Approved Final Butte Priority Soils Operable Unit (BPSOU) Unreclaimed Sites Field Sampling Plan (FSP) Package #7: UR-01, UR-12, UR-03, UR-04, UR-15, and UR-17

RE: Response to Comments to the Butte Priority Soils Operable Unit (BPSOU) Unreclaimed Sites Draft Final Field Sampling Plan (FSP) Package #7: UR-01, UR-12, UR-03, UR-04, UR-15, and UR-17

**Butte Priority Soils Operable Unit (BPSOU) Unreclaimed Sites Final Field Sampling Plan (FSP)
Package #7: UR-01, UR-02, UR-03, UR-04, UR-15, and UR-17**

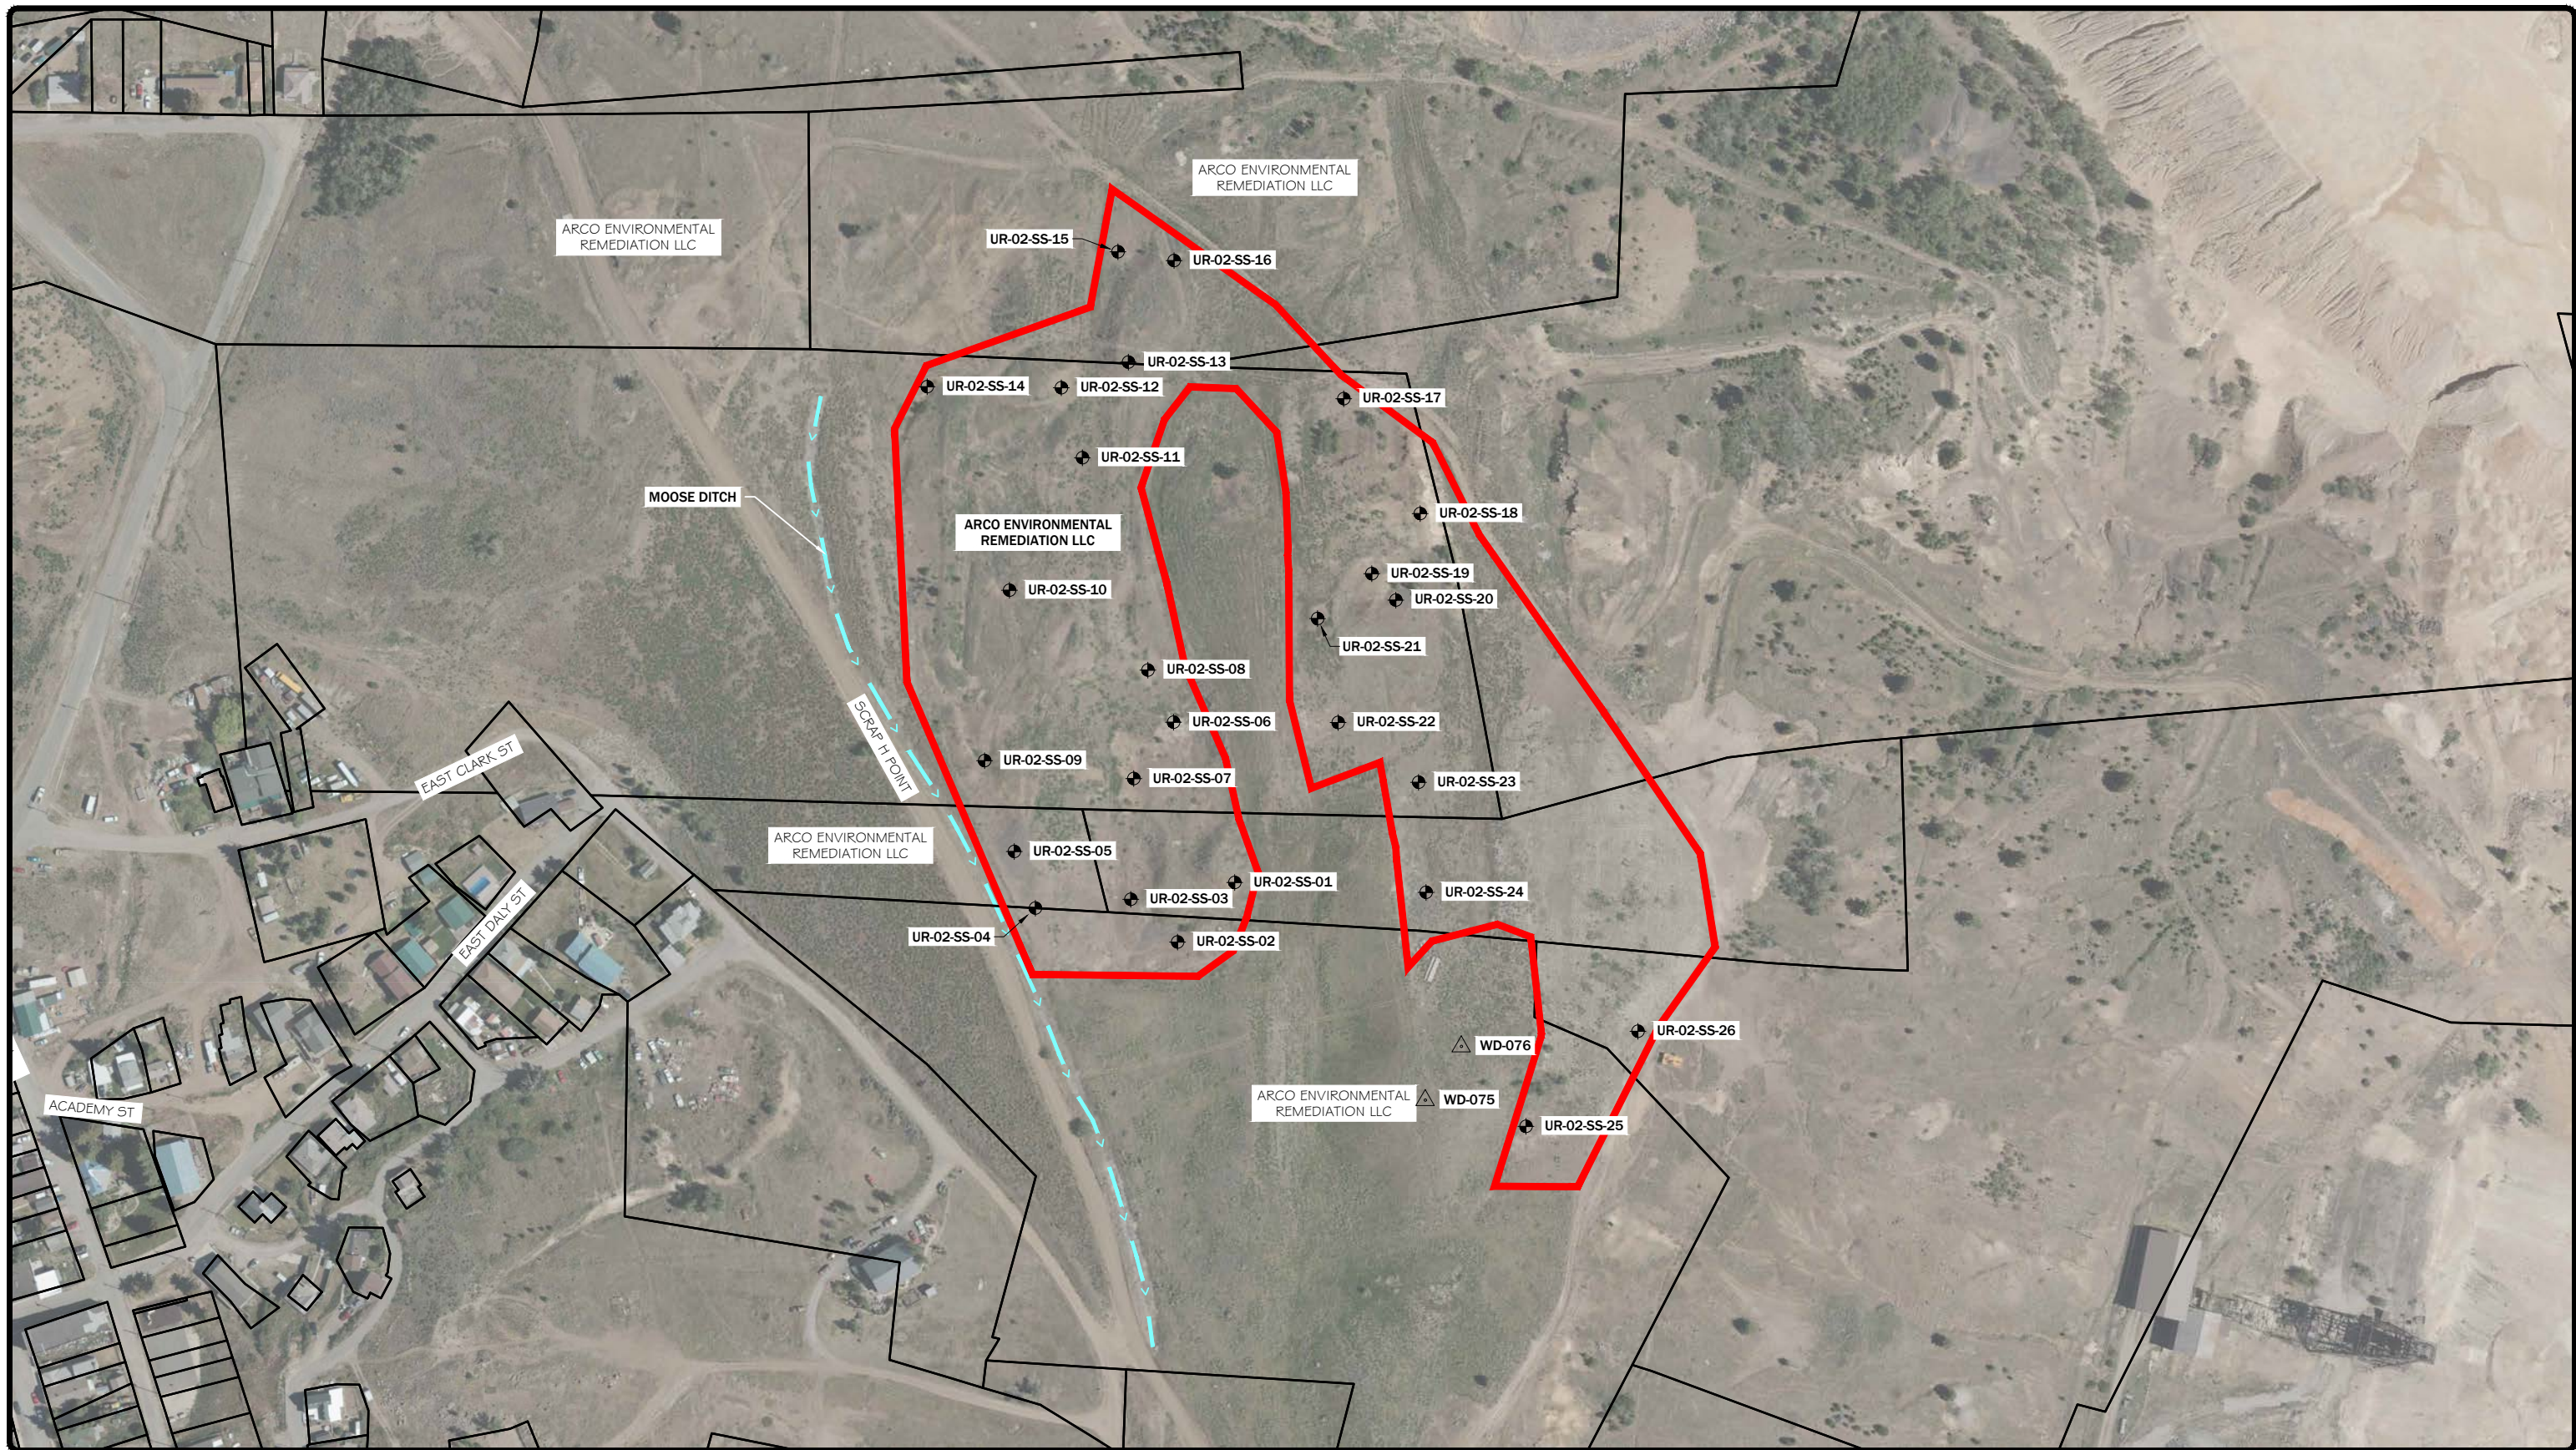
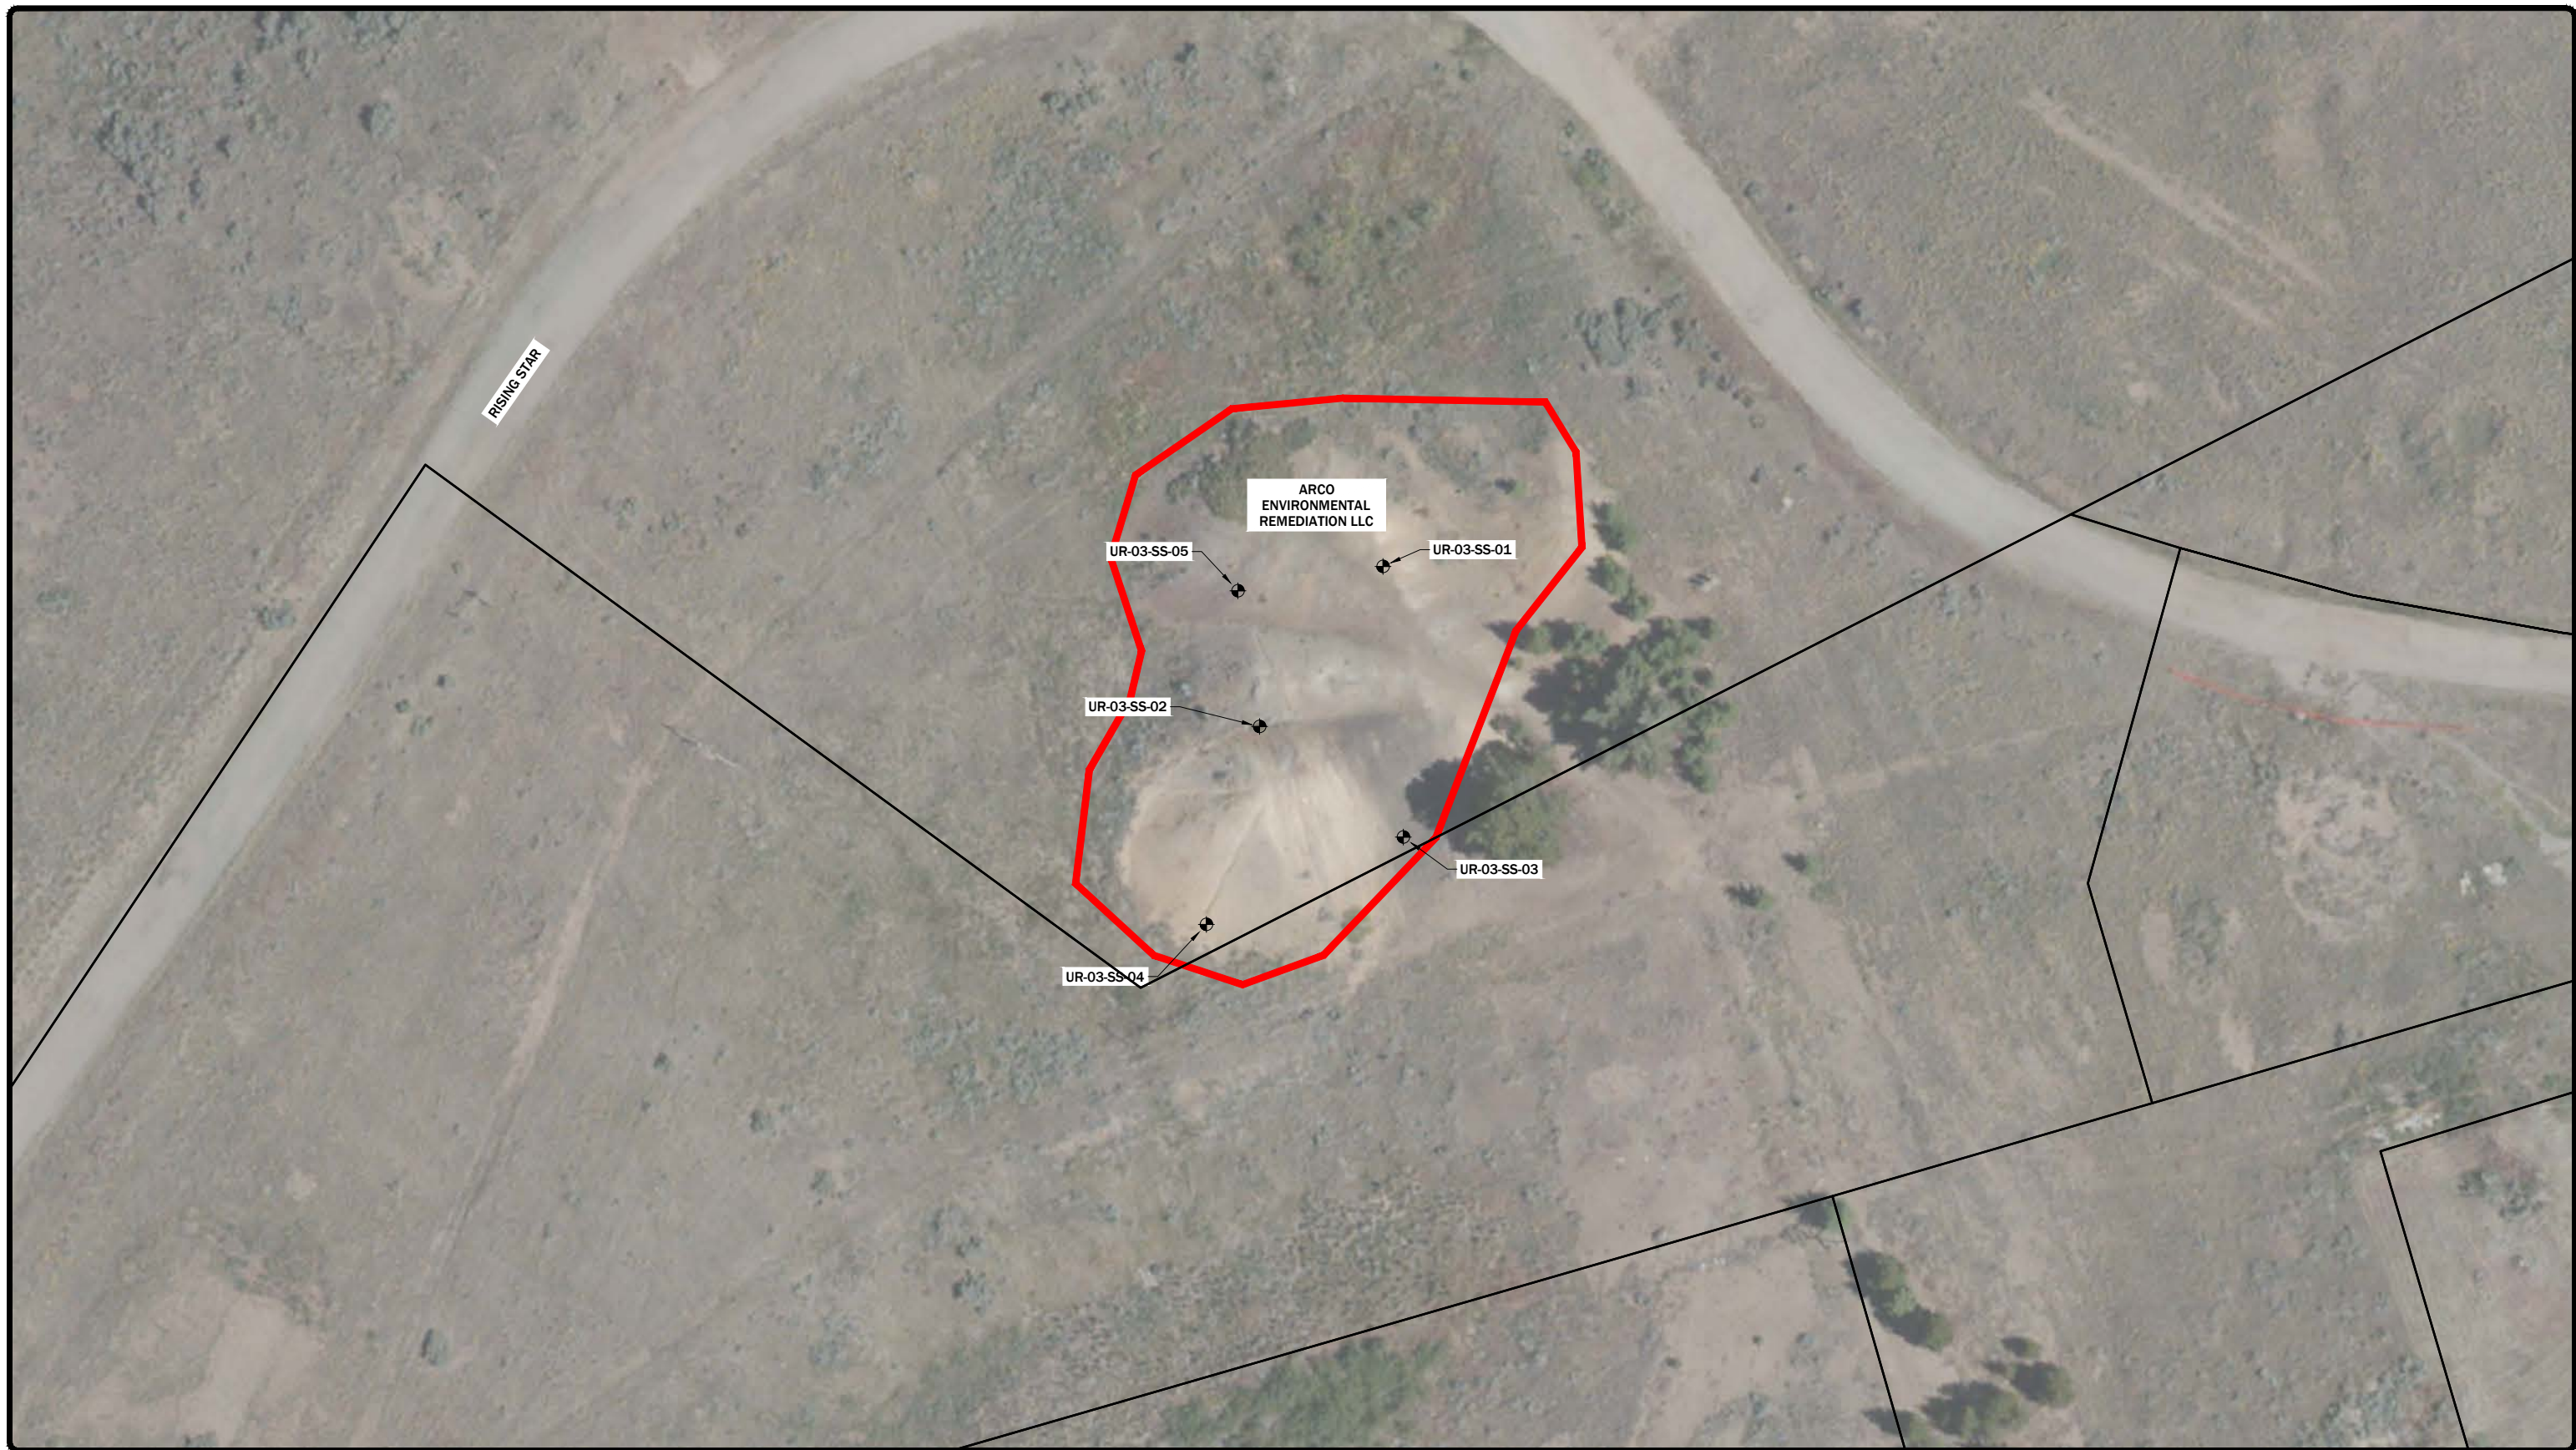
Please remove the private property owner names or business names from all figures.

Atlantic Richfield Response: Private property ownership and business names have been removed from figures and text.
